LINCOLN PARK PLANNING COMMISSION

Site Plan Review

Applicant	Roger Canzano
Project	Auto Sales
Address	881 Southfield Rd. Lincoln Park, MI 48146
Date	May 12, 2021
Request	Site Plan Review

Hennessey Engineers, Inc., completed our first review of the plans for the Planning Commission submittal dated April 10, 2021 and received via email from you.

SHEET TITLE
PROJECT NAME
 ADD USED CAR SALES TO
 EXISTING AUTO REPAIR
SITE PLAN

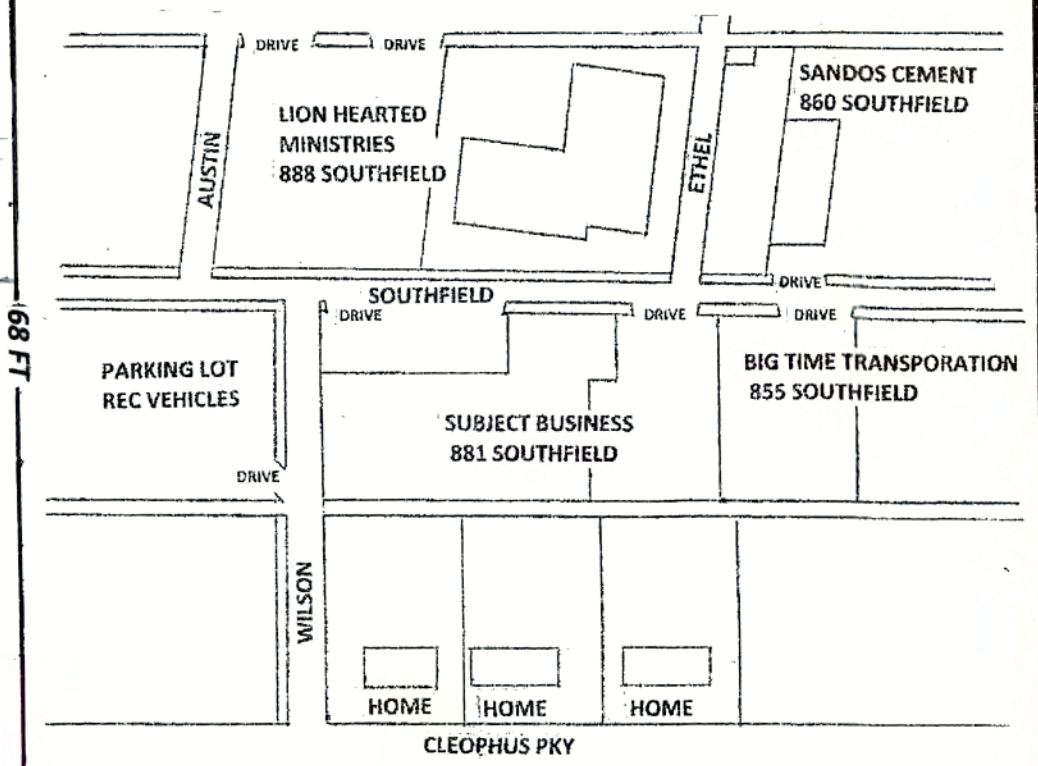
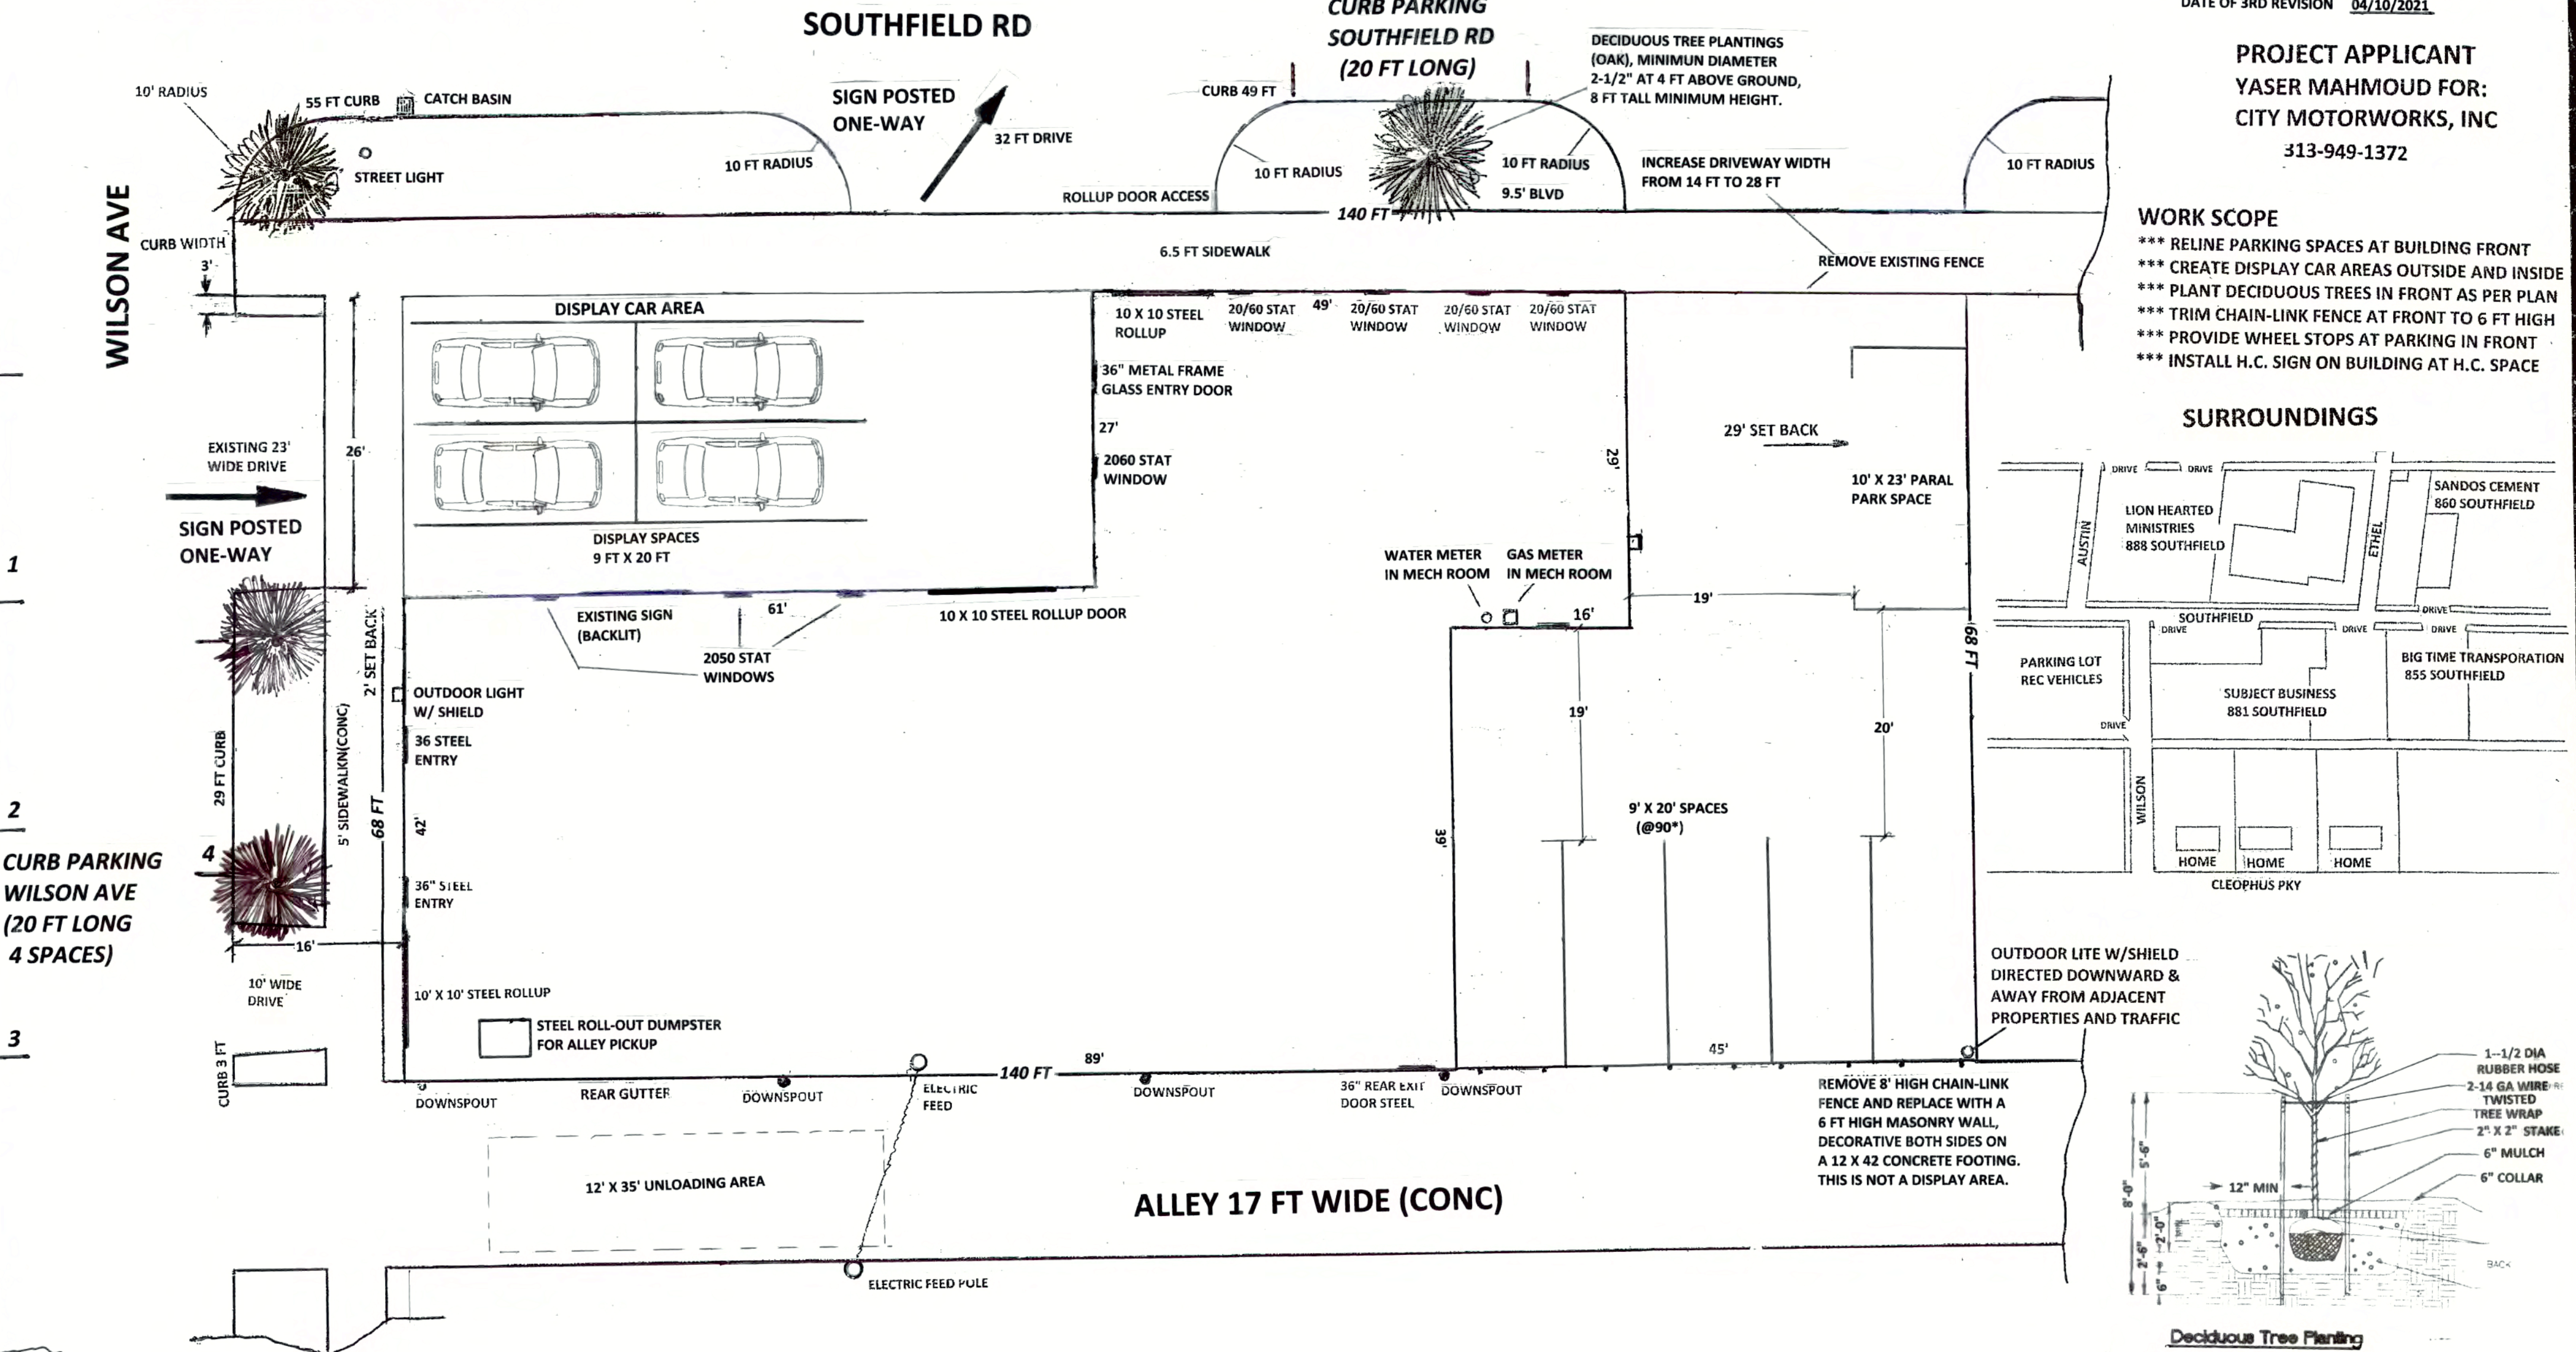
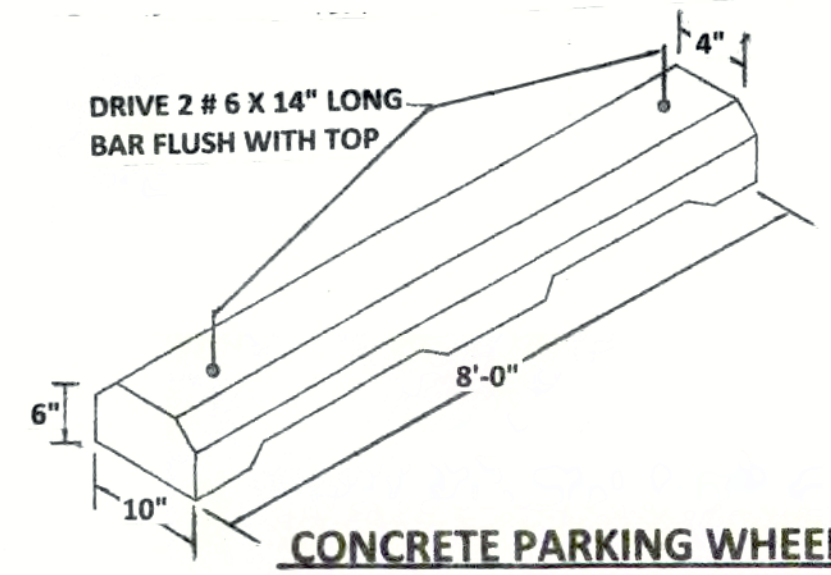
Engineering comments state that the plans (Sheet 01, Site Plan) are difficult to understand and that it is difficult to determine what is being proposed and what is to remain. There should be a separate plan showing the existing conditions and one showing what is proposed.

7. The plans are difficult to understand. I cannot determine what is being proposed and what is to remain. There should be a separate plan showing what are the existing conditions and what is being proposed.

8. The plans call for a 6.5 foot walk along the front of the building. Currently, there is not a walk along the front of the building. The proposed sidewalk area is asphalt pavement and is part of the existing parking for the building. There should be a designated concrete sidewalk constructed along Southfield Road that will tie into the sidewalk on the adjacent property. The sidewalk must be constructed in accordance with City of Lincoln Park and Wayne County Standards. Sidewalk details and cross-sections must be provided at the time of the detailed engineering review.

9. The plans do not indicate any improvements are going to be made on the existing asphalt parking lot. The existing parking lot (Display Area) is in poor condition. It should be brought up to City of Lincoln Park Standards. Pavement details and cross-sections must be provided at the time of the detailed engineering review.

10. Currently, cars are being parked in the proposed sidewalk area. There must not be any parking allowed from the proposed sidewalk to the road.
11. The plans call for parking on the east side of the building. This area was fenced off land and I could not determine the condition of the existing pavement. If the pavement is in poor condition it should be replaced and brought up to current City of Lincoln Park Standards.

12. In the Southfield right of way the plans are calling for landscaping and an increase in the size of the east drive approach from Southfield Road. These will require Wayne County review and approval. A permit will be required.

- The plans must be signed by the Professional Engineer.*
- The applicant shall provide a two separate sheets for the site plan – one for existing conditions and one for proposed changes.*

ELEVATIONS

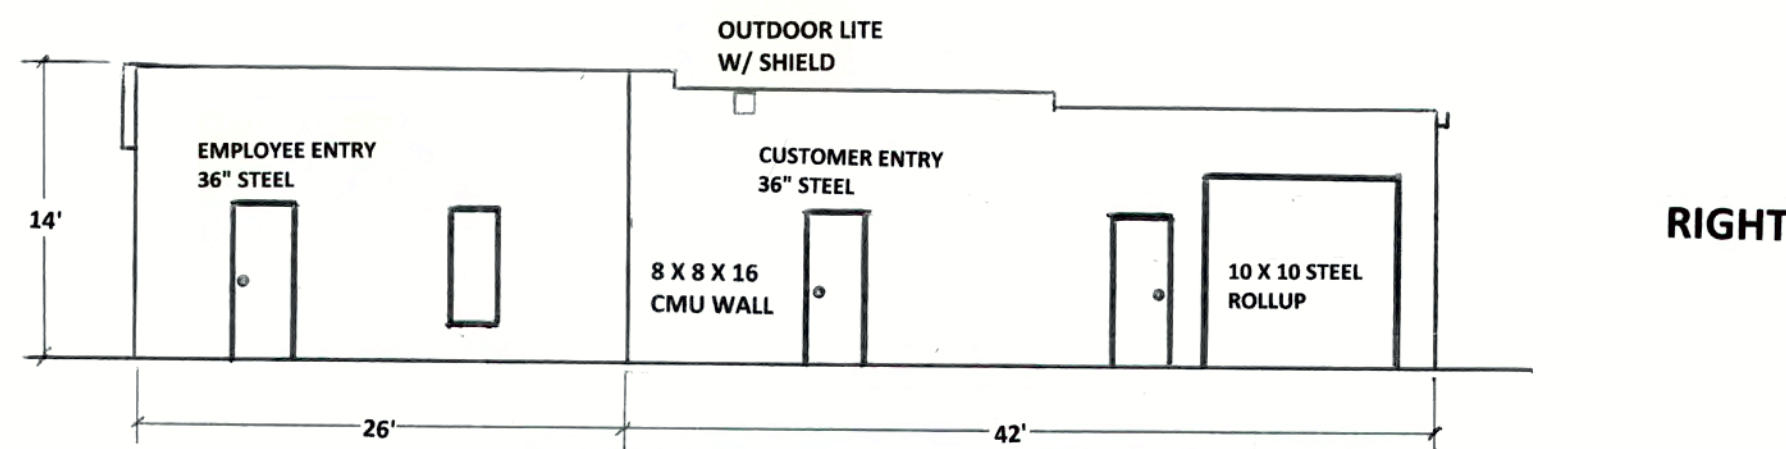
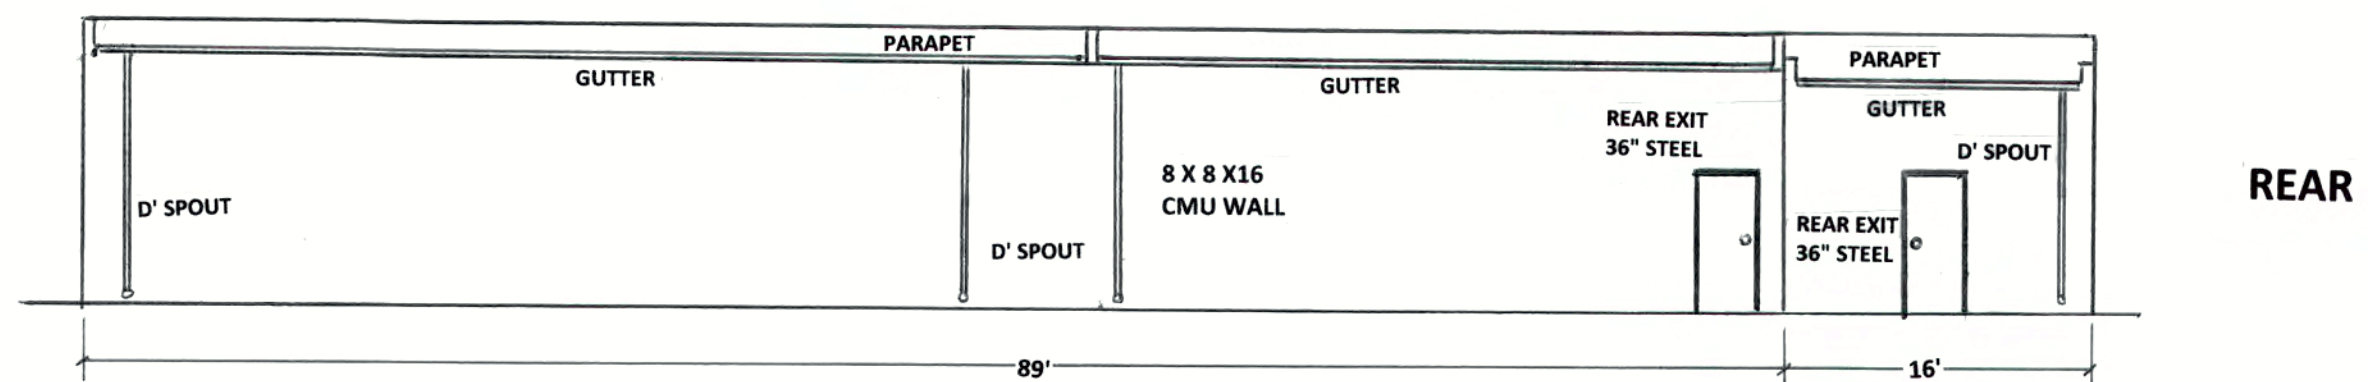
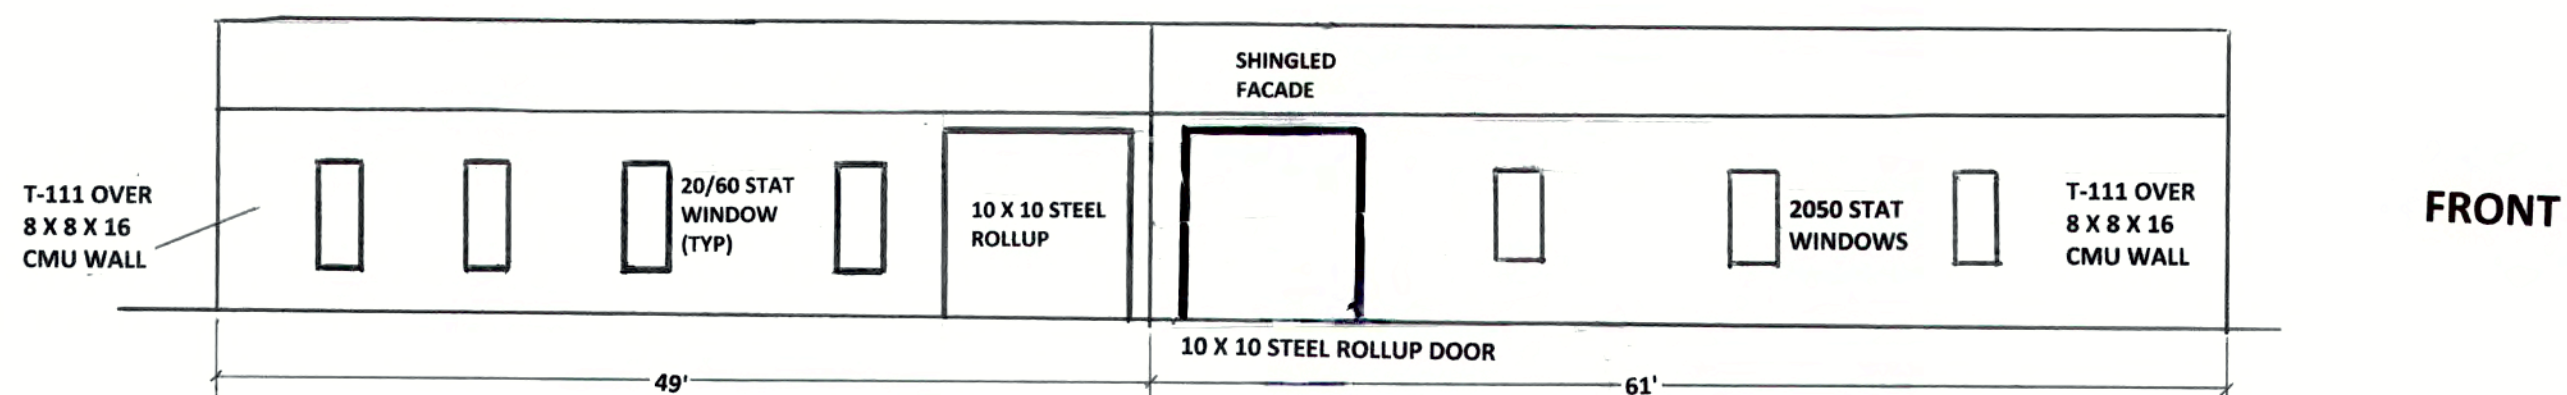
The building materials and transparency (windows) do not meet the standards but may be preserved so long as the nonconformity is not increased. The plan notes that “all elevations will remain the same except the 10 x 10 steel rollup door on front elevation will be closed off,” but does not indicate the material or manner that will be used to do so. As the proposal does not include changes to the building façade, the City has historically permitted existing façade conditions to remain.

- *Sheet 06 to indicate method and materials used to close off steel rollup door. Existing and proposed elevations shall be shown for all facades which will be changed.*
